SUNDRY NOTICES AND REPORTS ON WELLS

1 Type of Well: ☑ Oil Well ☐ Gas Well ☐ Other	5 Lease Serial No: LC-060529
	6. If Indian, Allottee or Tribe Name
	7 If Unit of CA/Agreement, Name and/or No.
	8 Well Name and No.: Beeson "F" Federal No. 5
2 Name of Operator: Southern Bay Operating, L.L.C.	9 API Well No: 30-015-04399
3a Address: 110 Cypress Station Dr , #220, Houston, TX 77090 — 3b. Phone No. *(include area code)*: 281-537-9920	10 Field and Pool or Exploratory Area: Loco Hills QN-GB-SA
4 Location of Well *(Footage, Sec , T ,R.,M., or Survey Description)*: 2297' FNL & 1646' FEL, Unit G - S31-T17S-R30E	11 Country or Parish, State: Eddy

Beeson "F" Federal 5
30-015-04399
Southern Bay Operating, L.L.C.
October 27, 2009
Conditions of Approval

Beeson "F" Federal #5
Loco Hills
Eddy County, NM
Current Condition

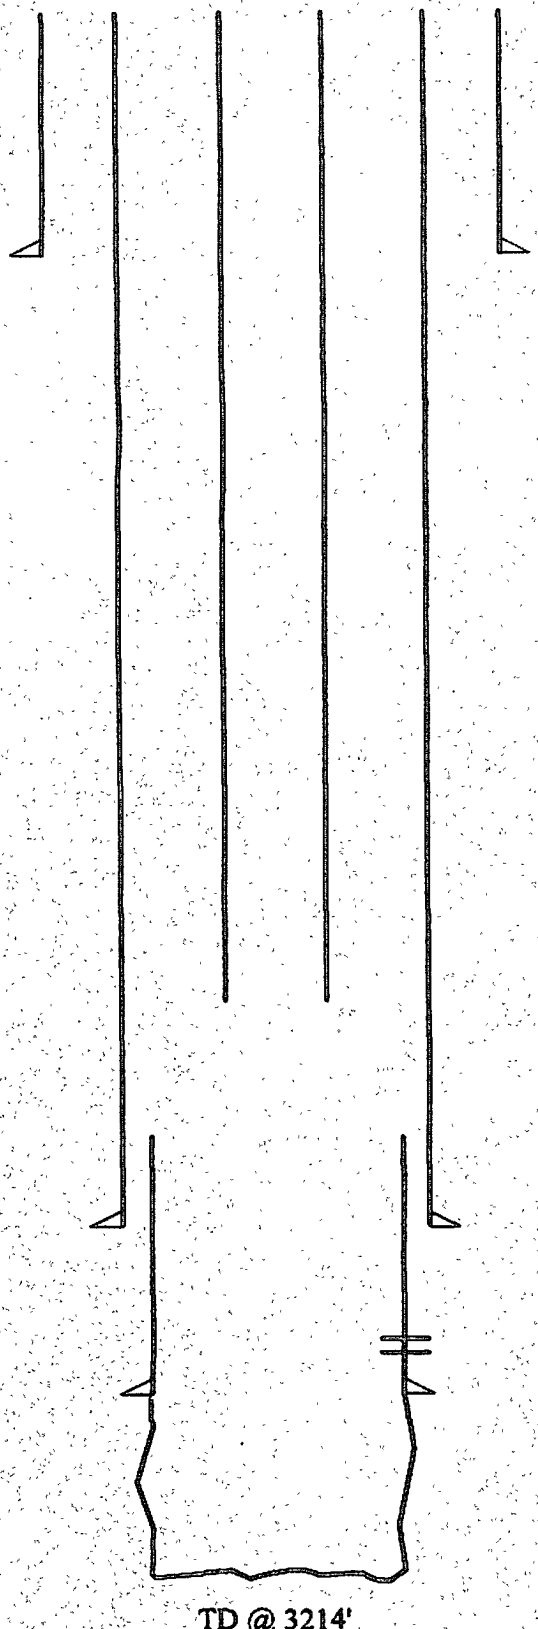
1. Step 1 – Ok.
2. Step 2 – Ok.
3. Step 3 – Spot 100 sxs Class C neat at 3,214'-2,533'. WOC tag plug at 2,533' or shallower. Liner shoe at 2,896', intermediate shoe at 2,722', liner stub at 2,656' and the top of the Grayburg is at 2,633'.

4. Step 4– **Moved plug.** Perf. at 1242'. Squeeze 40 sxs Class C neat. WOC tag plug at 1,132' or shallower. Top of Yates at 1,192', also serves as base of salt plug.

5. Step 5 – Perf. at 669'. Sqz 40 sxs Class C neat. WOC tag plug at 559' or shallower. Surface casing shoe at 619'.
6. Step 6 – Perf. at 505'. Attempt to establish an injection rate, if possible pump 40 sxs. If injection rate cannot be established set 25 sx plug from top of previous plug. WOC tag plug at 405' or shallower. Top of salt at 455'.

a. Perf 10' above tag, attempt to establish circulation to surface in the 8-5/8" x 7" annulus and outside the 8-5/8" casing. If injection rate cannot be established, perforate at 60'and attempt to establish injection rate. If injection rate can be established, pump plug from lower perforations and up to surface in annulus and in 7" casing.

7. Step 7 – Cut csg. 3' below GL and verify cement came to surface on all annuli. If cement did not come to surface in the annuli 1 inch to surface. Install dry hole marker
